REVISIONS			
No.	Date	Item	
3	9/24/25	ADDENDUM #3	
5	10/13/25	ADDENDUM #5

D-111

SITE PLAN - PROCESS

CITY & BOROUGH OF YAKUTAT
WATER SYSTEM EXTENSION

PROCESS SITE PLAN

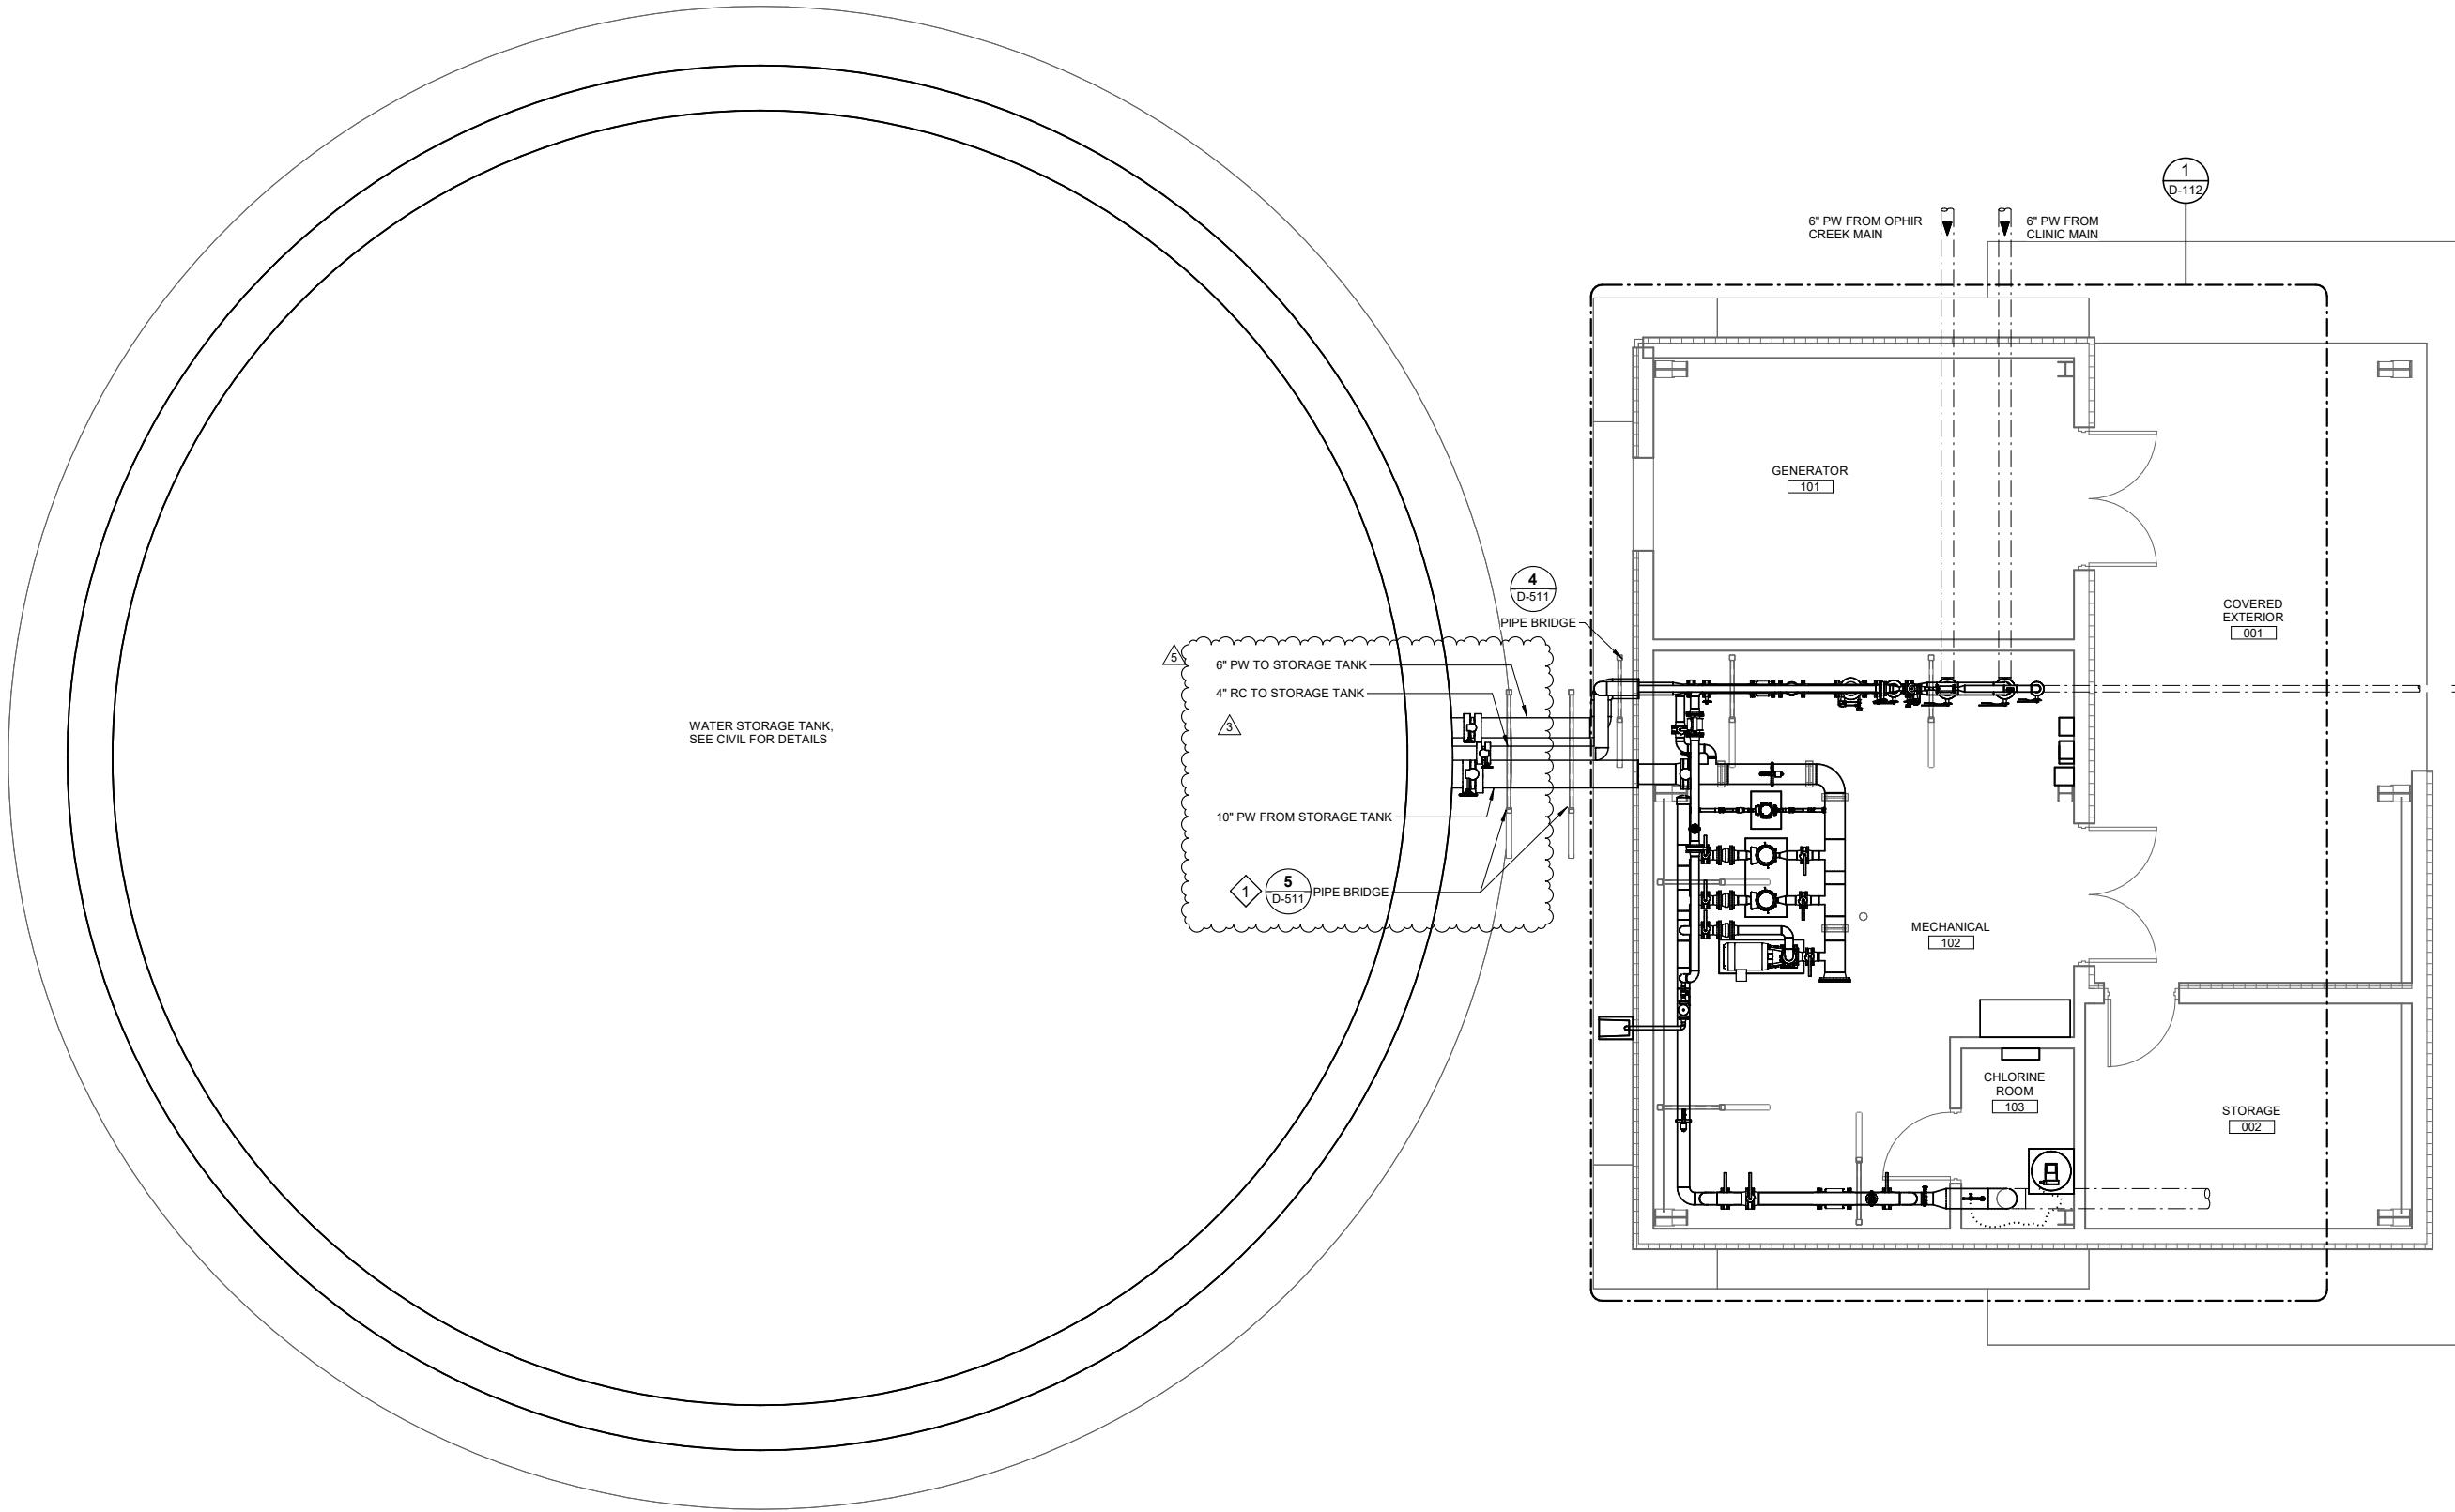
1. BRIDGE SPACING TO BE FIELD ADJUSTED TO ACCOMMODATE VALVES AS DIRECTED BY ENGINEER.
